PUBLIC STORAGE

9701 AURORA AVE N., SEATTLE, WA

DPD PROJECT #: 3020310

DESIGN REVIEW BOARD MEETING: DESIGN REVIEW RECOMMENDATION #2

RESPONSE TO BOARD GUIDANCE - LANDSCAPE CONCEPT

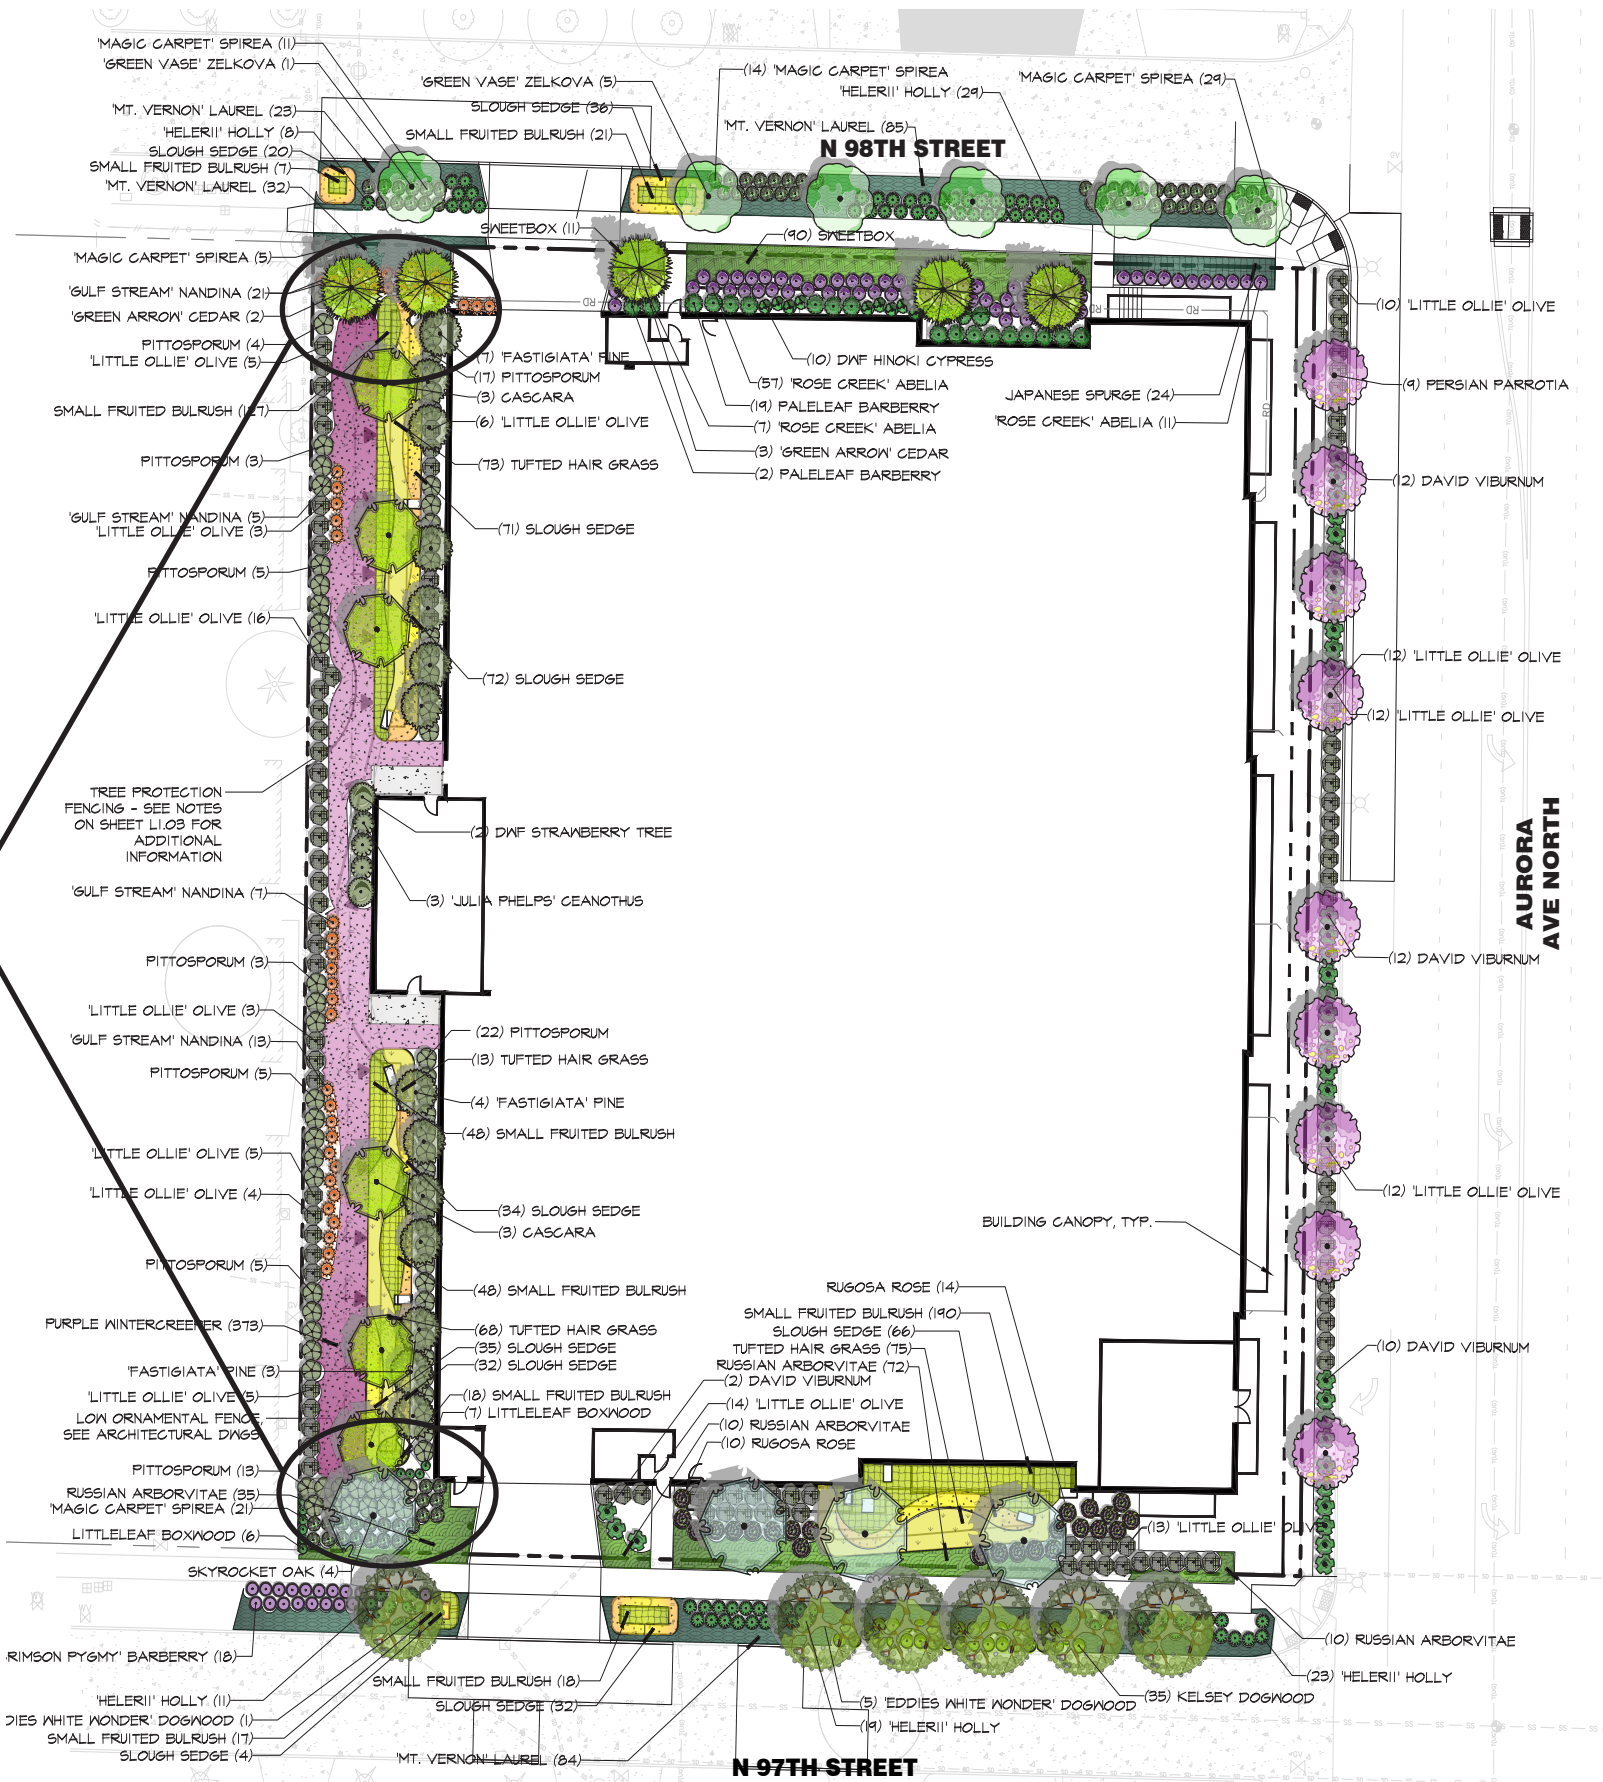
2.b. The Board acknowledged public comment by recommending the installation of trees at a caliper larger than the minimum required by code.

2.d. Include in the second recommendation packet an updated landscape plan.

The City of Seattle code requires deciduous trees in the street right-of-way to have a minimum caliper tree of 1.75 inches and a height of 10 feet and coniferous and broadleaf evergreens to be at least five feet in height. In other landscape areas deciduous trees are required to have a minimum caliper of 1.5 inches and a height of 10 feet and coniferous and broadleaf evergreens to be at least five feet in height. The project proposes to provide deciduous trees at a 2 inch caliper with heights that vary from 10 to 14 feet and evergreen trees with heights between 6 and 8 feet.

The landscape plan has been updated to reflect previous changes.

RETAIL OFFICE AT SOUTHEAST BUILDING CORNER; NOT TO SCALE

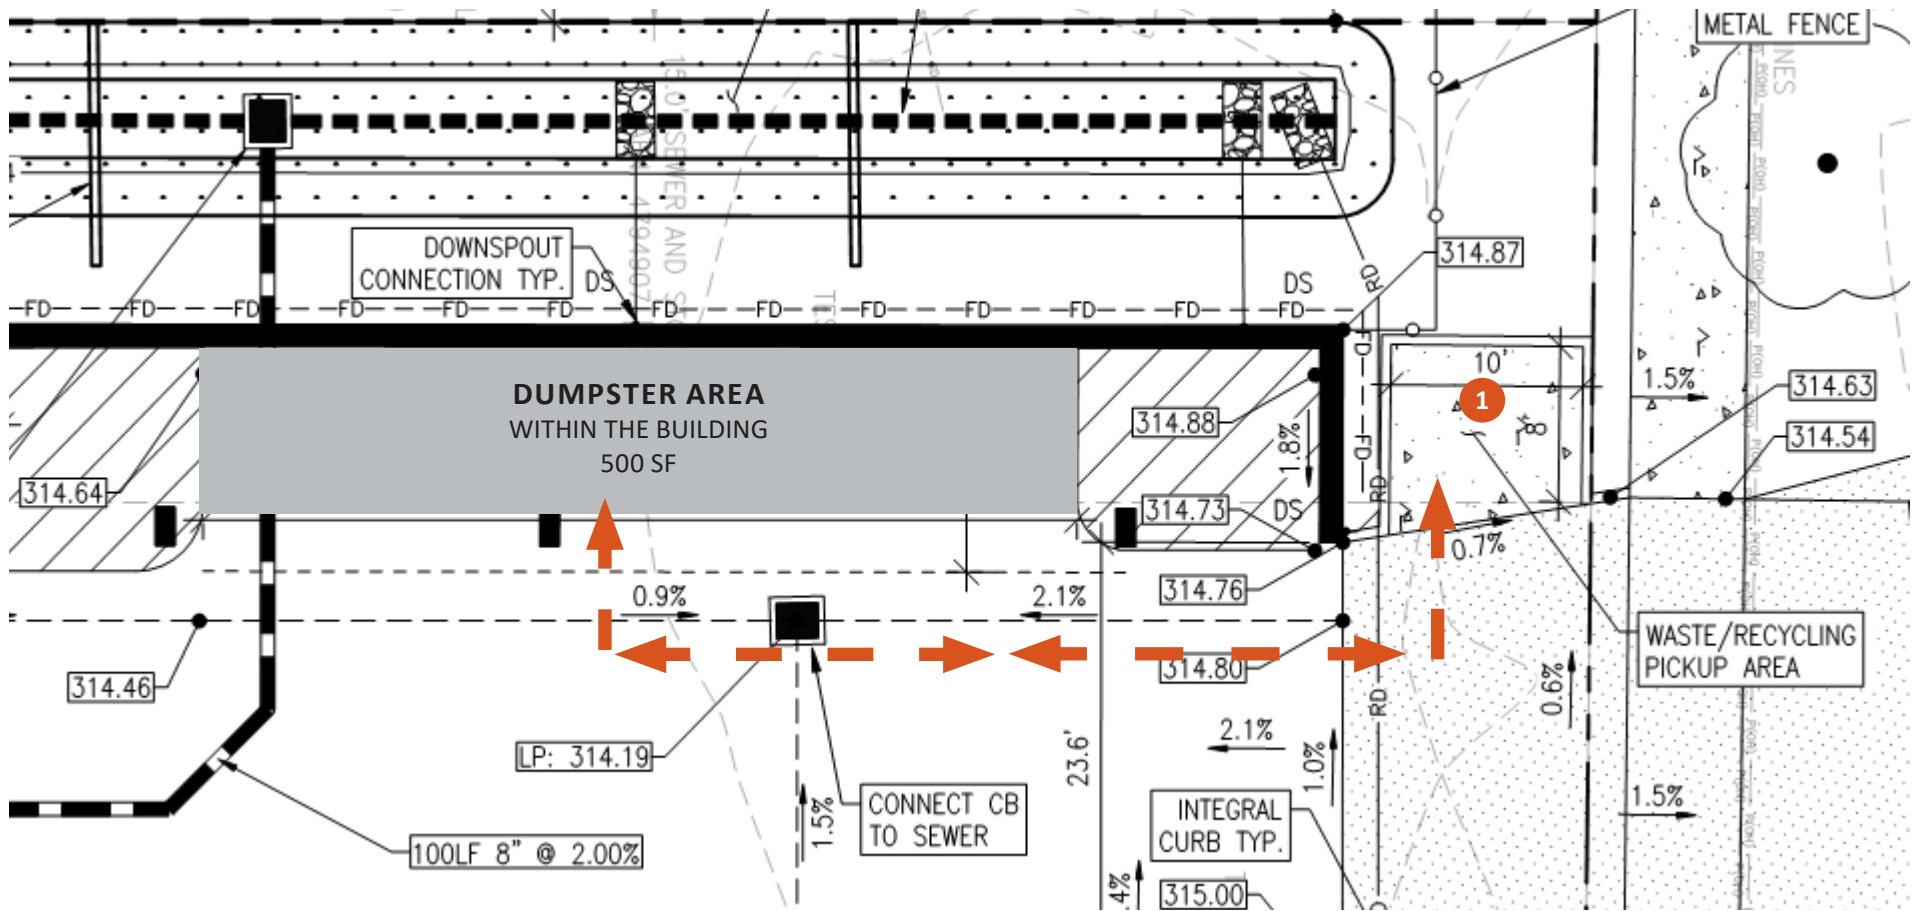
BOARD COMMENT:
3.b. In response to the guidance provided during the EDG phase, the retail office was moved from the garage to the southeast corner of the site. This move was supported by the Board who agreed with public comment that activity and eyes on the street in this location is important. (CS3-A, PL2-B)

RESPONSE:
As demonstrated in the previous packet and at the DRB Recommendation meeting, the retail office will be located on the southeast corner of the building and will include large storefront windows, canopies, and pedestrian scale signage.

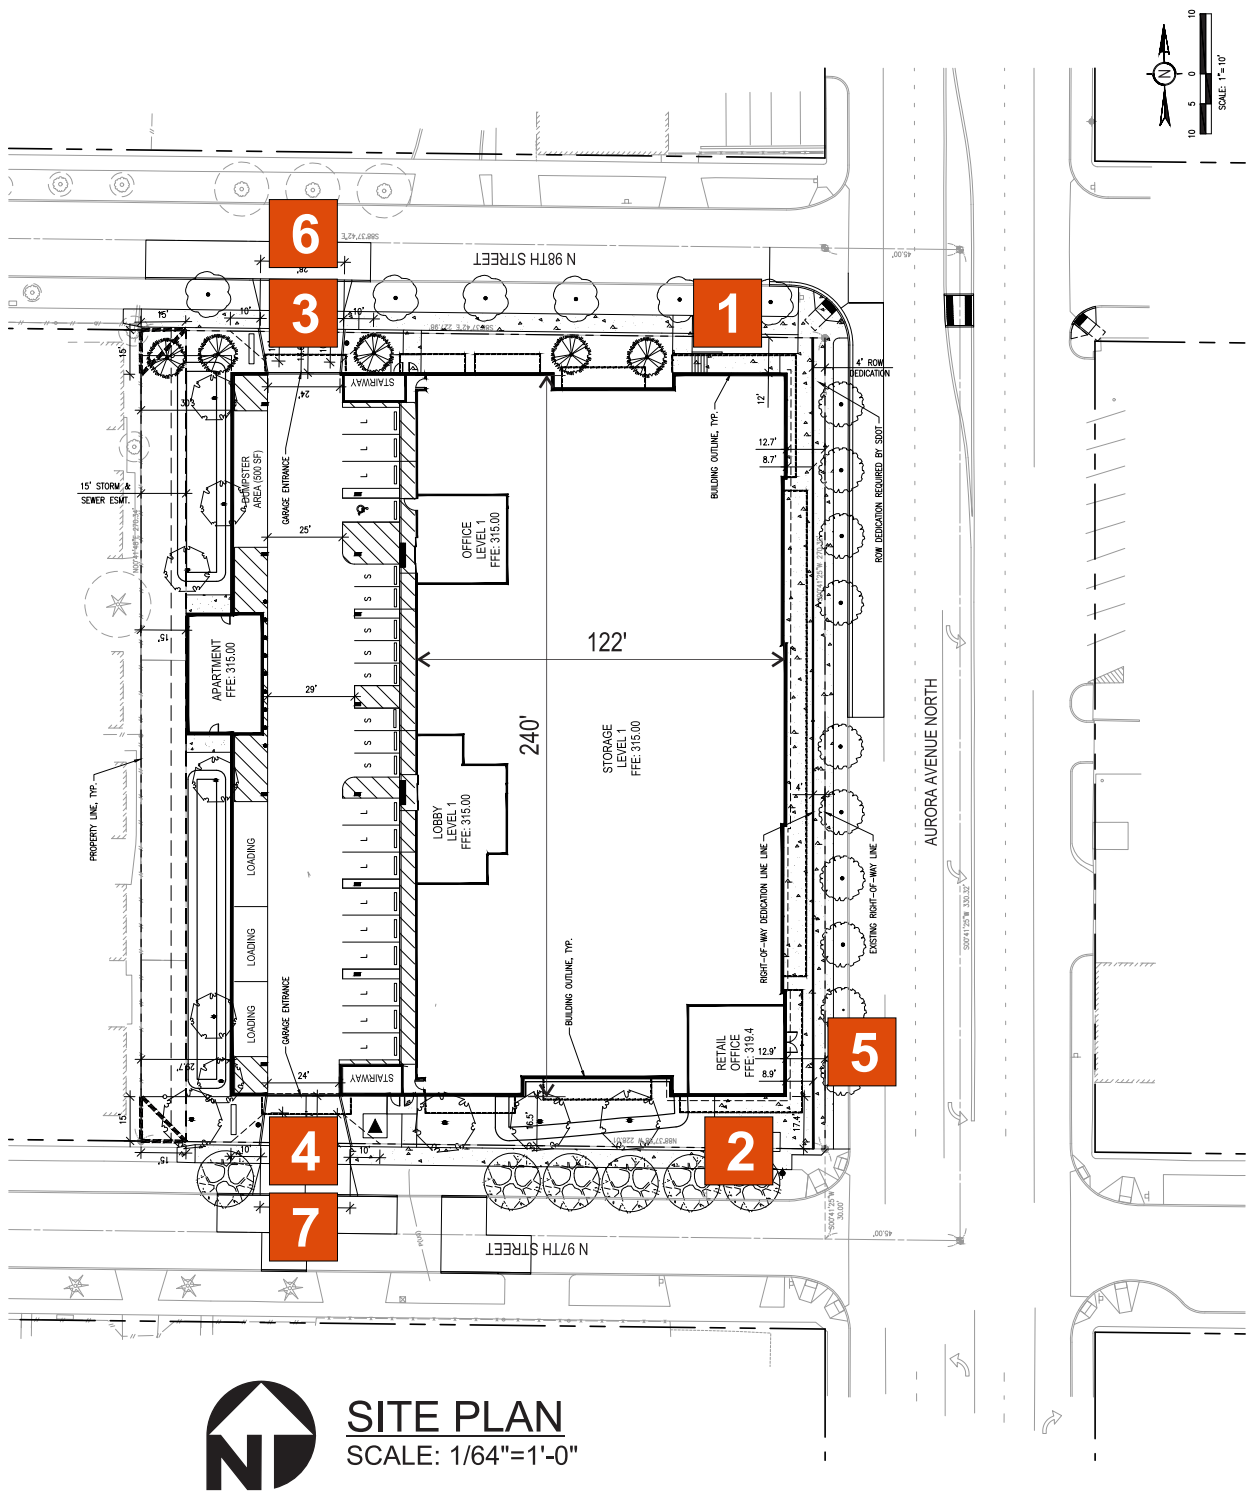
BOARD COMMENT:
3.c. Solid waste and recycling storage was proposed within the garage, near the northern entrance to N 98th St. The Board agreed with public comment noting that the staging area should be within the structure, not in the public right-of-way. The Board recommended this change be made by the next meeting. Include details in the second recommendation describing conceptually how the solid waste and recycling will be picked up and approximately how often. (DC1-C)

RESPONSE:
The solid waste and recycling area is located within the building and has been sized to meet the provisions of the Seattle Land Use Code. Waste and recycling containers will be stored within the building until collection day.

In coordination with Waste Management, the refuse provider for this location, the container(s) will be pushed outside the building to a concrete pad on the north side of the building on collection day. Once emptied, the container(s) will returned to the dumpster area within the building.

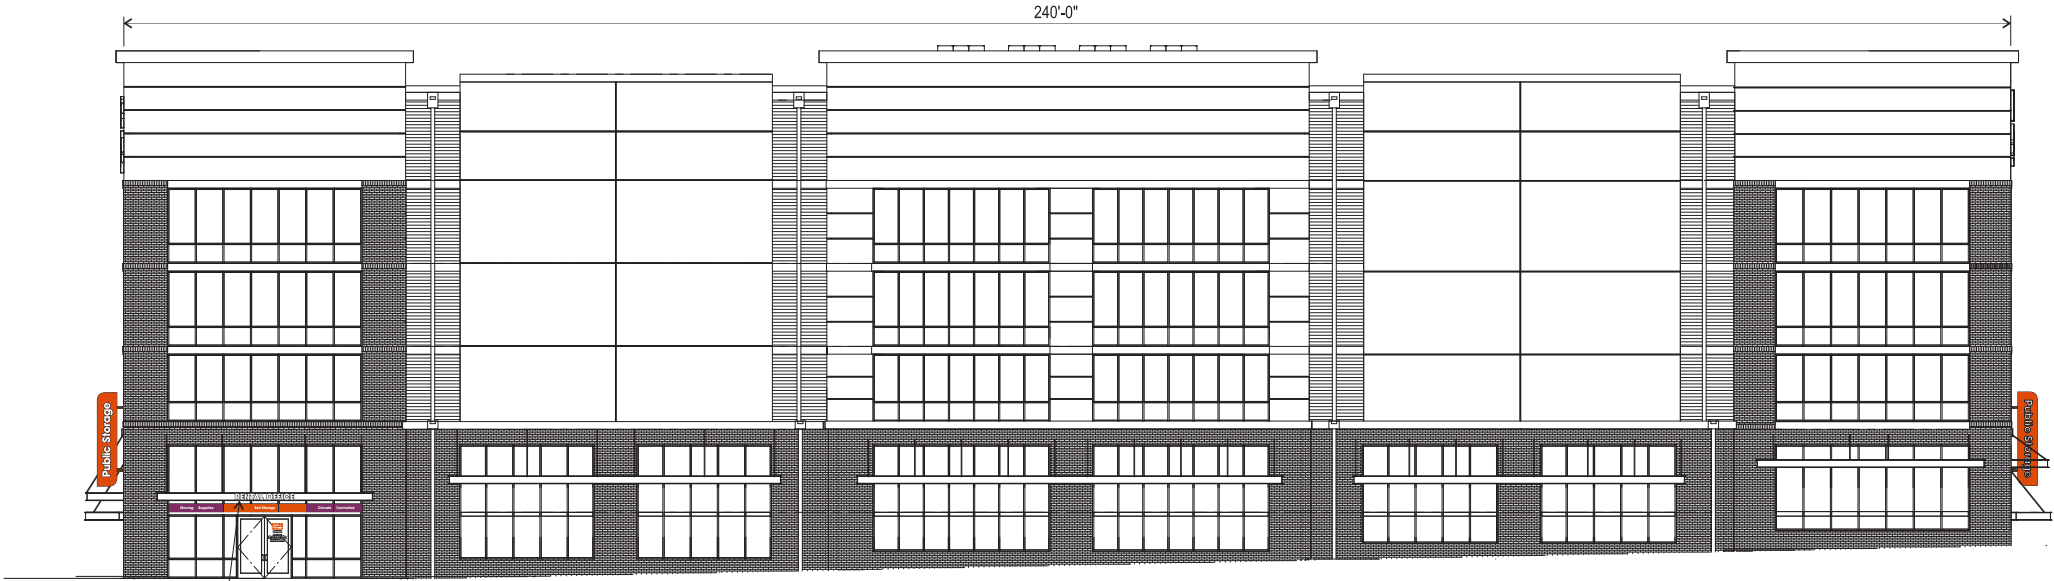
4. Signage. While a conceptual signage plan was not included in the Recommendation packet, signage was depicted on the elevations and renderings. As depicted on page 43 of the Recommendation Packet (June 5, 2017), large signage was proposed at the north- and southeast corners (facing both Aurora and N 97th and 98th Streets), while blade signs were proposed at levels two and three. The Board agreed these signs were oriented to the vehicle and out of scale with the context and residential character of the abutting development to the west. Furthermore, the Board agreed the use of “Public Storage Brand Orange” at the corners acted as a sign and failed to provide a positive or desirable context for others to build upon in the future. The Board recommended signage of a pedestrian scale along Aurora Ave N, reduction of the signage proposed at the upper levels, and elimination of the “Public Storage Brand Orange” at the ground level. Include in the second recommendation packet a conceptual signage plan to include dimensions and details describing material, lighting, attachment, and color. (CS3-A, DC4-B)

The Public Storage signs at the top of the NE and SE tower elements have been reduced in quantity from four signs to two. Pedestrian scale signs have been added at the retail office in the SE corner of the building.

The project proposes seven (7) wall signs, each under the maximum sign area allowed.

RESPONSE TO BOARD GUIDANCE - LIGHTING

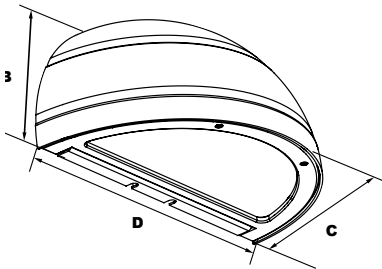
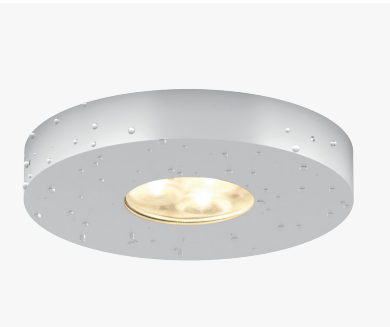
5. Exterior Lighting. The exterior lighting plan on page 47 of the Recommendation Packet (June 5, 2017) was found to be incomplete. Include in the second recommendation packet a lighting plan that includes details describing the type of lighting proposed (include lumens and graphics of lighting type proposed). The Board agreed with public comment that lighting for safety and security is important for this site. (DC4-C)

The lighting plan has been updated to include fixture information and locations on the building and site. Building lighting will be directed downward to avoid light trespass onto adjacent properties.
